## Report to the Sydney Western City Planning Panel on an application for a site compatibility certificate - State Environmental Planning Policy (Housing for Seniors or People with a Disability) 2004

**SITE:** 121-133 Prairie Vale Road, Bossley Park (part Lot 7 DP 664803 and part Lot 1 DP 332770). The land subject to the proposed seniors housing development has an area of 1.5ha. The site is part of the larger Club Marconi site and is proposed to be located above an existing car park.

**PROPOSAL:** Seniors housing village.

Figure 12: Proposed overshadowing on 21 June at 9am and 3pm.

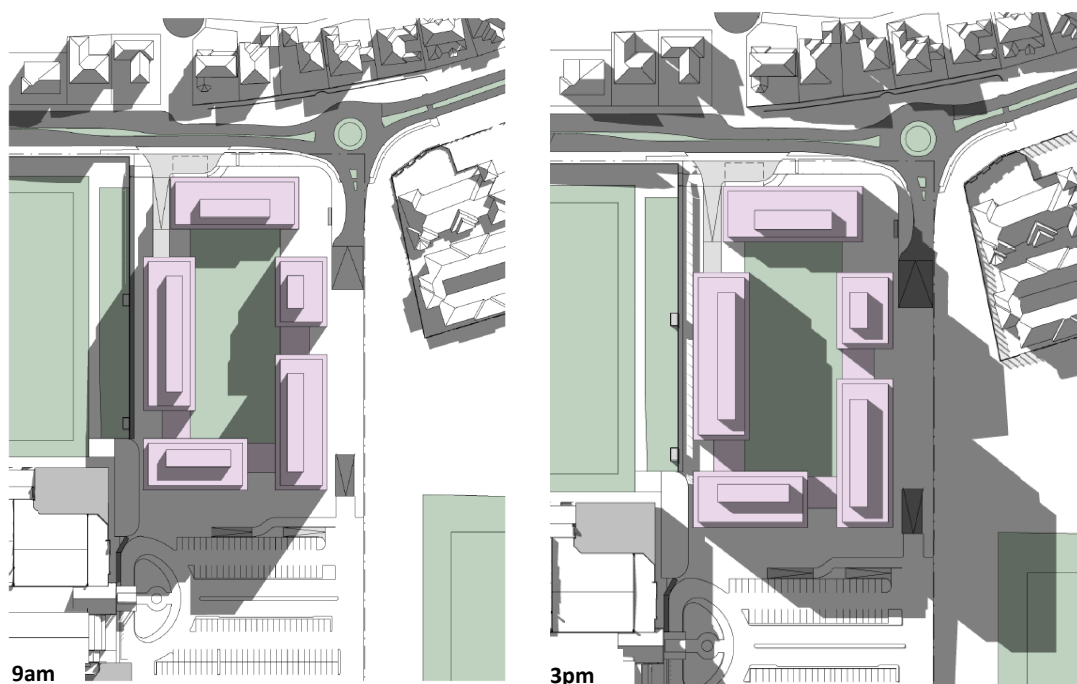
The shadow diagrams (page 35 of **Attachment B3**) illustrate that the proposed development will create additional overshadowing across the Club Marconi car park and minor shadow over Marconi Park after 3pm (Figure 12 below). A large portion of the central communal courtyard will also be overshadowed during the winter solstice at 9am and 3pm.

The shadow diagram may change as further investigations into the final bulk and scale of the proposed development are undertaken at the development application stage. It is recommended that overshadowing of Marconi Park is avoided to ensure there is no impact on the current quality of the public open space.

- internal and external overshadowing including no shadow cast over Marconi Park;
  - privacy of adjacent private property;
  - traffic, pedestrian mobility and access; and
